# Avalon University District

Design Review Recommendation Meeting  
August 15, 2011

DPD Project No.: 3011958 (East Parcel)  
DPD Project No.: 3011959 (West Parcel)

# Response to DRB Recommendations

## **2. Driveway Turning Radii Overlap**

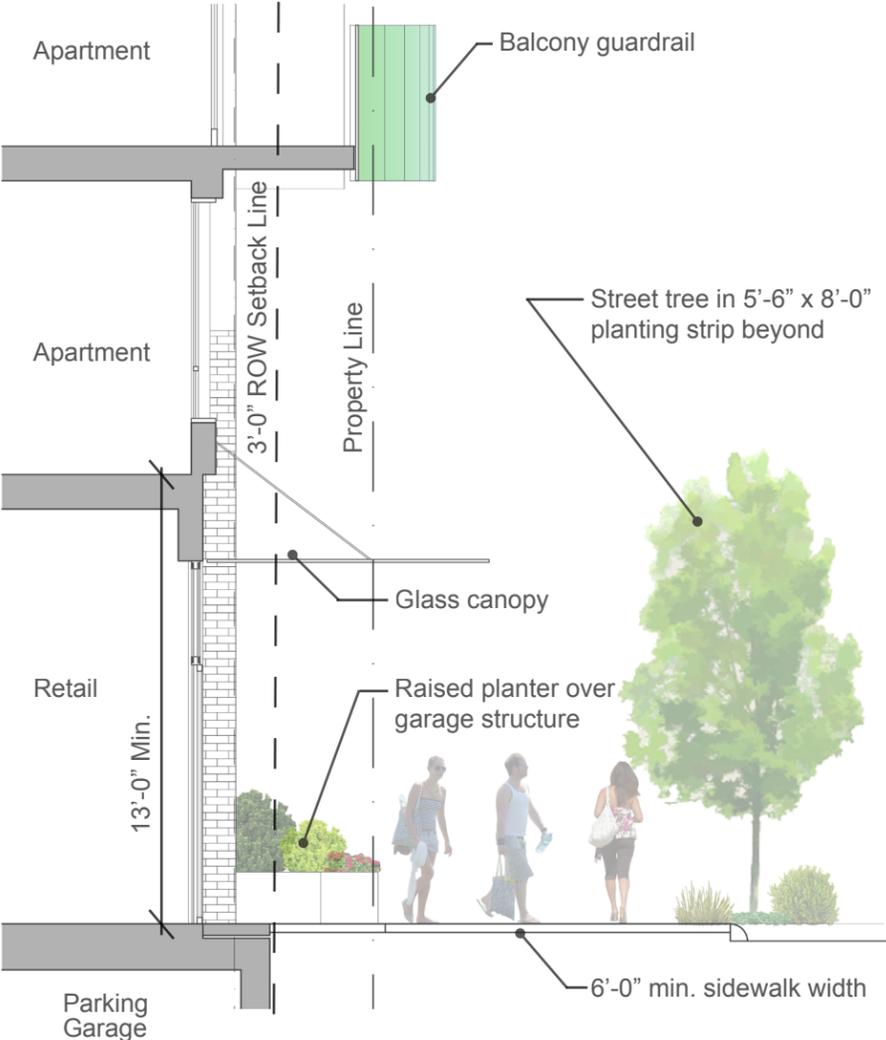
Turning radii for two-way traffic at the top and bottom of the parking garage entry ramps to overlap one another.

Parking is not required for the project, but is being provided as an amenity for residents and visitors. Exhibit B noted above implies that roadways leading into and out of the radii be 24 foot wide. The 20 foot alley width at the top of the garage entry ramps does not accommodate this dimension. The 22'-6" wide access aisle proposed at the bottom of the East garage entry ramp also does not accommodate the 24 foot dimension. The project proposes to allow the turning radii of opposing traffic to overlap one another and will provide appropriate traffic markings and signage to alert motorists to exercise caution when approaching the entry ramps.
